To: T10 Technical Committee  
 From: Rob Elliott, HP (elliott@hp.com)  
 Date: 28 April 2007  
 Subject: 07-119r2 SAS-2 Far-end retimed loopback phy test function

## **Suggested changes to SAS-2**

**Figure 1 — Far-end retimed loopback phy test mode**

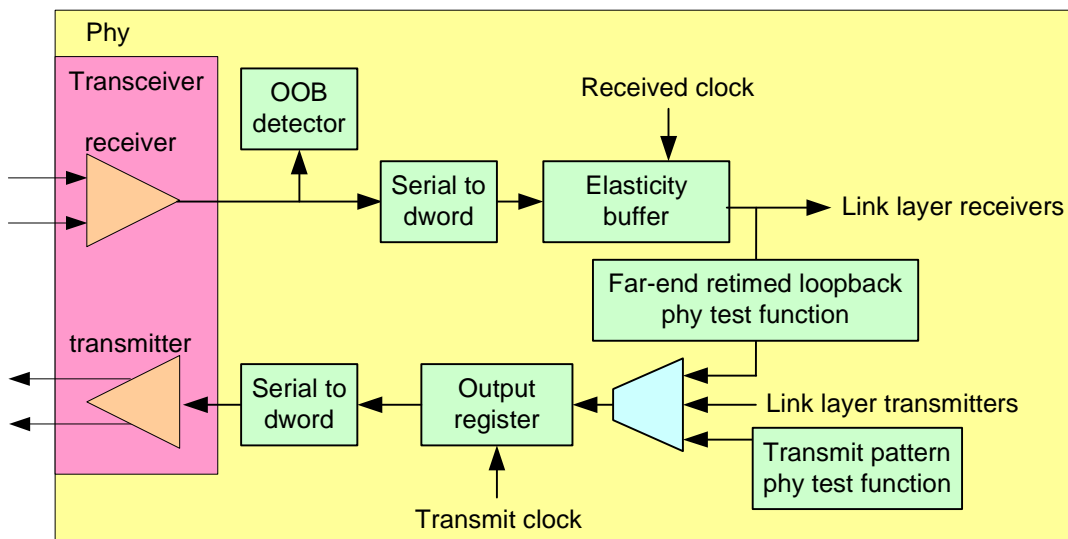
#### **4.10.3 Far-end retimed loopback phy test function**

While performing the far-end retimed loopback phy test function, the phy:

- a) shall maintain dword synchronization and receive dwords into loopback buffer;
- b) may delete deletable primitives as necessary to avoid overflowing an elasticity buffer (see 7.3);
- c) shall either delete invalid dwords, convert them into ERROR primitives, or preserve their 10 bit patterns. The phy should not delete invalid dwords;
- d) shall retransmit using the transmit clock each dword that was not deleted;
- e) shall transmit a deletable primitive whenever the transmitter underflows (i.e., whenever the transmitter is ready to transmit a dword but the receiver has not provided another dword to transmit); and
- f) shall transmit dwords using valid disparity based on the transmitted dword stream. The disparity for a dword after an invalid dword is vendor-specific.

Figure 1 shows the far-end retimed loopback phy test mode.

**Figure 2 — Far-end retimed loopback phy test mode usage**

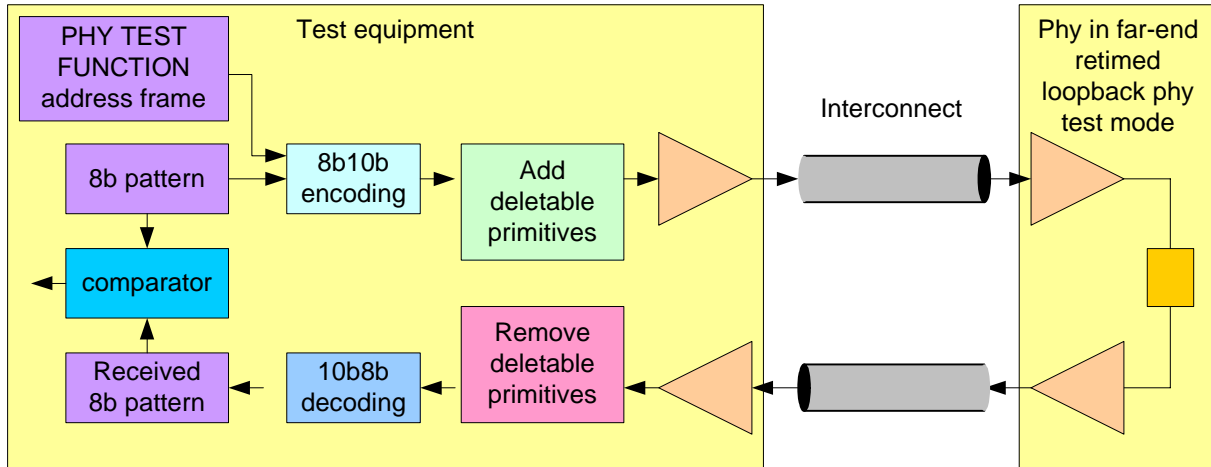
Figure 1 shows usage of the far-end retimed loopback test mode.
